Economic Commission for Europe**Inland Transport Committee****World Forum for Harmonization of Vehicle Regulations****Working Party on Passive Safety****Sixty-fourth session**

UN Regulation No. 129 (Enhanced Child Restraint Systems)**Proposal for Supplement 9 to the 00 series of amendments,
Supplement 6 to the 01 series of amendments, Supplement 5
to the 02 series of amendments and Supplement 2 to the 03
series of amendments to UN Regulation No. 129****Submitted by the expert from the European Association of Automotive
Suppliers***

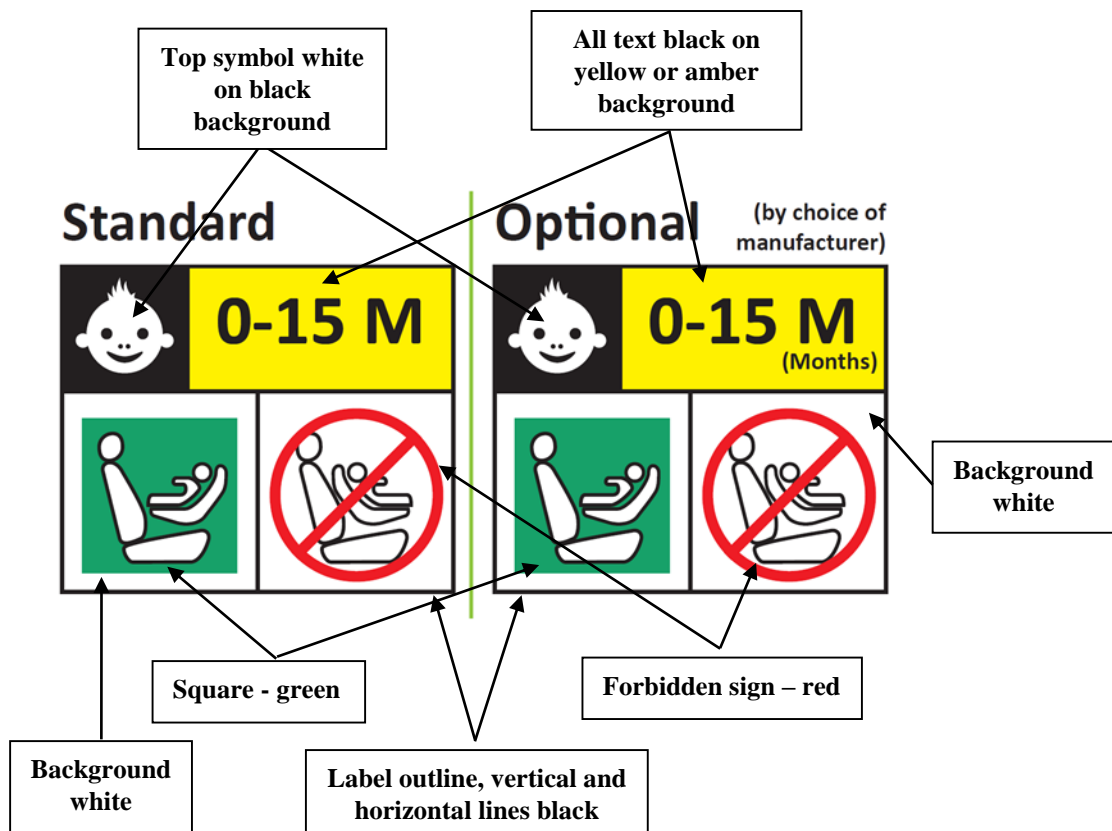
"4.5. ~~In the case of~~ Integral Enhanced Child Restraint Systems that can be used forward **and rearward** facing, ~~it~~ shall have the following label permanently attached on the part hosting the child and visible to the person installing an Enhanced Child Restraint System in the vehicle:

1. The label defined in paragraph 4.5. warns parents against the use of a forward-facing Child Restraint Systems (CRS) for children aged 0 to 15 months. It includes a green pictogram of a child in a rear-facing CRS alongside a pictogram of a forward-facing CRS with a red ‘forbidden’ sign. The label is currently required on all Enhanced Child Restraint Systems (E CRS) with a forward-facing installation. This means that an E CRS with only a forward-facing installation must carry a label that includes a rear-facing CRS. This is potentially misleading and may lead parents to try to install their E CRS rear-facing, against the manufacturer’s instructions

2. This proposal specifies the label to be used for convertible E CRS only. It defines a new label for E CRS with a forward-facing installation only that emphasised the E CRS should not be used by children under 15 months.

Minimum label size 40 x 40 mm

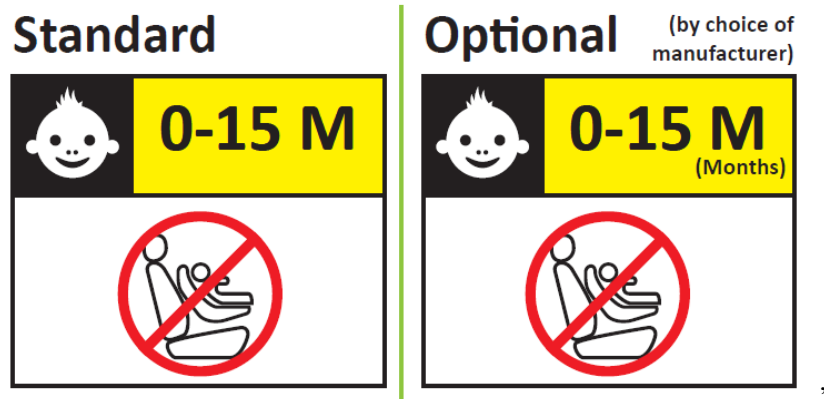
Integral Enhanced Child Restraint Systems that can be used forward facing only shall have the following label permanently attached on the part hosting the child and visible to the person installing an Enhanced Child Restraint System in the vehicle:

Minimum label size 40 x 40 mm
